NUMBER
COR61615

**SOLICITATION NUMBER: COR61615**  
**Addendum Number: 1**

1. Responses to vendor questions attached with Exhibits 1 through 3.
2. Mandatory pre-bid meeting sign-in sheets attached.
3. Revised drawings attached.
4. The bid opening remains 7/23/13 at 1:30 pm.

### QUILLIAMS UNITS I AND II RECREATIONAL YARD METAL CAGES PROJECT

EXHIBIT #1

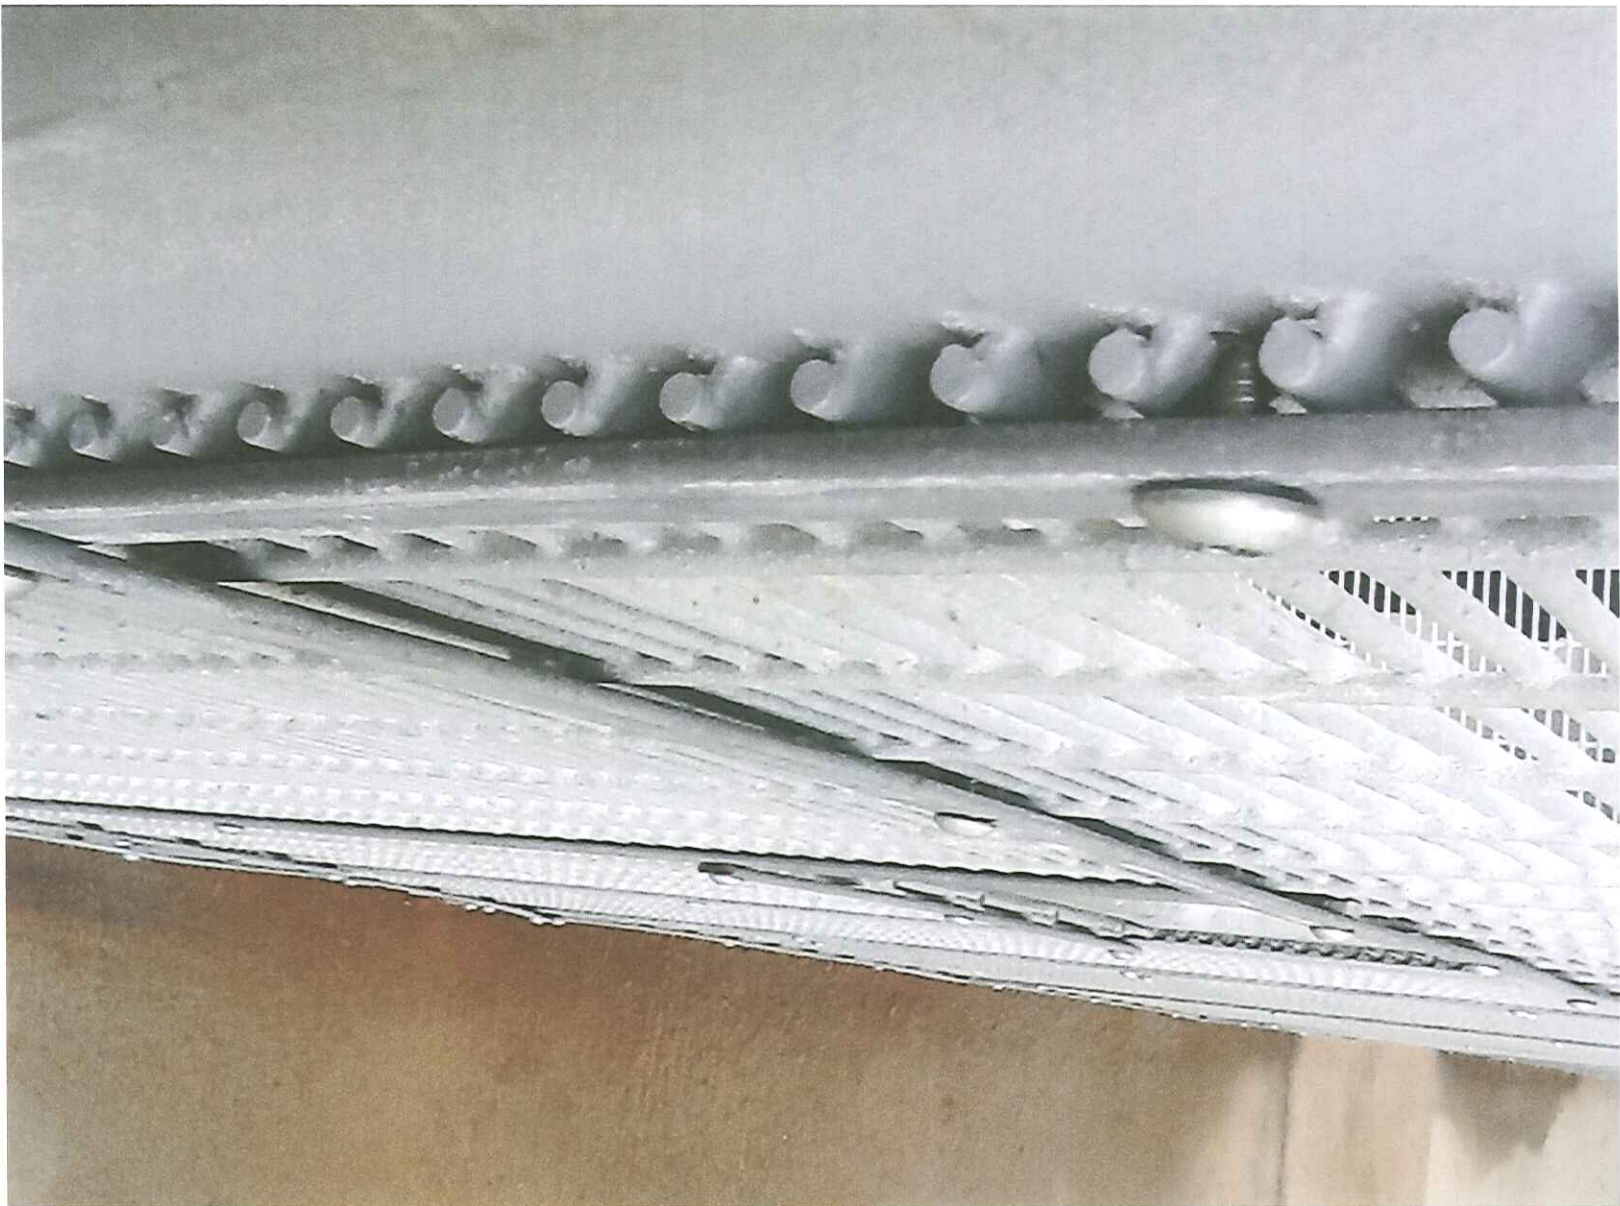
Q3: Phillip Farley had a picture of the security screen mesh at the pre-bid meeting. Could this also be provided to us?

Q4: May we have an electronic copy of the picture Philip Farley showed us at the Pre-Bid Meeting that showed details of how the metal mesh is to be attached to the supporting structure.

A3: Please see Exhibit #1.

A4: Please see Exhibit #1

DRAWING NO. 092-0230-008

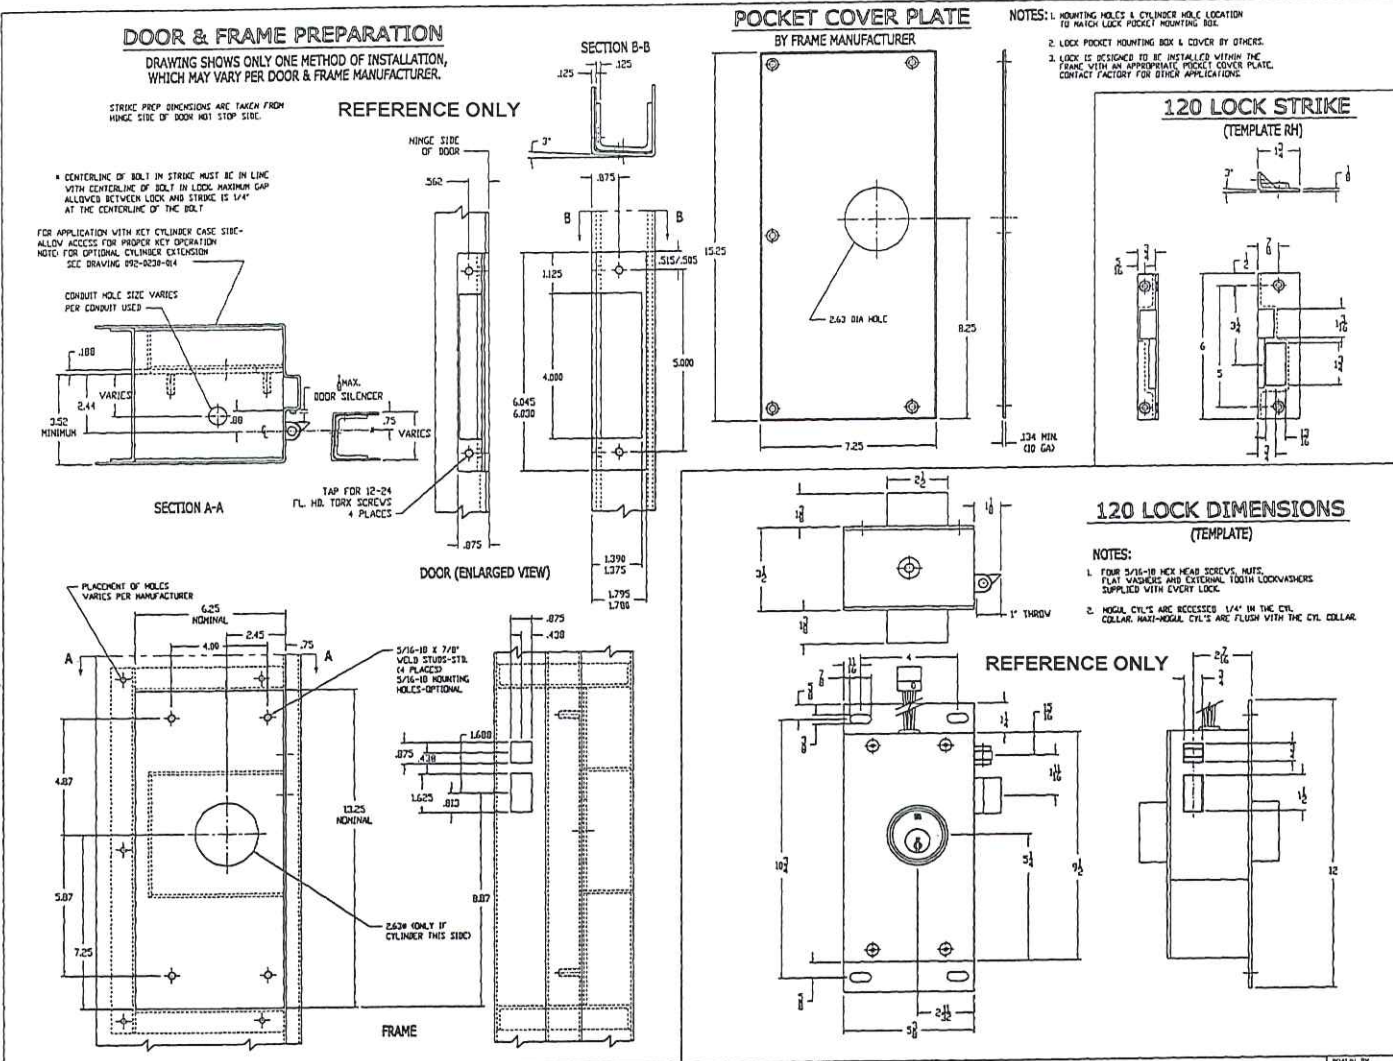
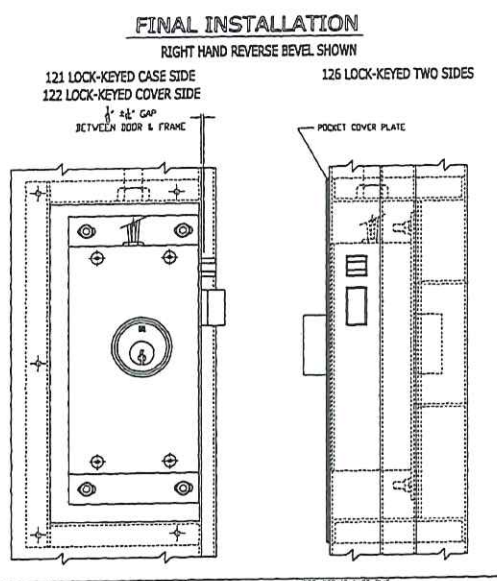
- C7: The security lock assembly for the door lock must have the following criteria and be tied into the existing locking control system. The conduit must be type rigid for the cables. See Exhibit #2 for template information.

Electronic/Mechanical Lock Assembly for Metal Cage 3:

- A. Manufacture for doors to the metal cage units:
1. Lock assembly for the doors to the metal cage 3.
    - a. Folger Adams Electronic/Mechanical Locks.
    - b. Or Equal.
  2. Description:
    - a. 120M Deadlatch, model 126.
    - b. Keyed on both sides.
    - c. Throw latch bolt must extend one (1") inches.
    - d. For door type: swinging.
    - e. For security level: maximum.
    - f. Lock Assembly must be welded to the metal doorframe.
    - g. It is the contractor's responsibility to size the door so install the lock assembly.
- C8: Please see Exhibit #3 for the pre-bid sign-in sheet.

A1-0

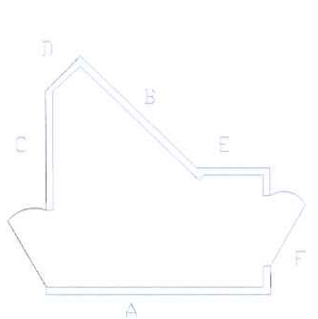
- C6: The security door that goes into the recreational yard area currently has an electronic controlled lock. The drawings for metal cage 3 have been changed to a different security lock assembly. The changes have been made to drawings CS-1, A1-0, A2-3, A3-3, and A4-1A. The drawings are attached.
